From: Lauren Harrison <lauren.harrison@watermanaspen.co.uk>
Sent: 27 October 2021 16:37
To: Planning Enquiries <planning_enquiries@herefordshire.gov.uk>
Cc: jennifer.allen2@balfourbeatty.com; Joel.Hockenhull@balfourbeatty.com
Subject: 213555 - Court Farm

SITE: Court Farm, Rectory Road, Hampton Bishop, Hereford, Herefordshire HR1 4JU
TYPE: Planning Permission
DESCRIPTION: Planning application for operational development following 210409/PA6 - Class R. This involves the removal of covered yards from the two, internal courtyards, as indicated previously on the drawings accompanying the 'prior approval' application and the insertion of doors and windows, predominantly within existing openings.
APPLICATION NO: 213555
GRID REFERENCE: OS 355357 238569
APPLICANT: Mr Layton
AGENT: Mr Ed Thomas

Figure 1: Environment Agency Flood Map for Planning (Rivers and Sea), October 2021

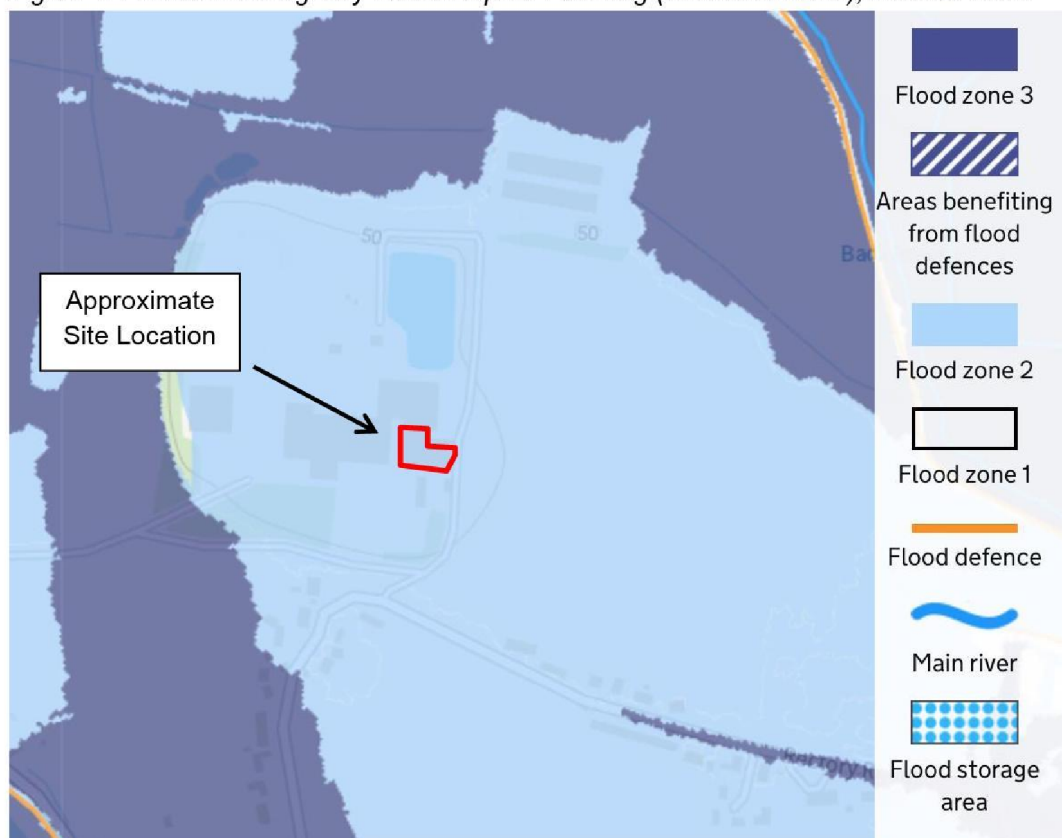
Review of the Environment Agency's Flood Map for Planning (Figure 1) indicates that the site is located within the medium probability Flood Zone 2.

The FRA should clarify the extent and depth of fluvial flood risk within the site boundary and consider the potential effects of climate change.

Anecdotal evidence suggests that the Site could also be at risk of flooding from the River Lugg as when its banks burst in February 2020, flood waters came within close proximity to the site. We are also aware that areas within the vicinity of Rectory Road have been subject to surface water flooding.

- Submission of a Flood Risk Assessment;
- Submission of a surface water drainage strategy.
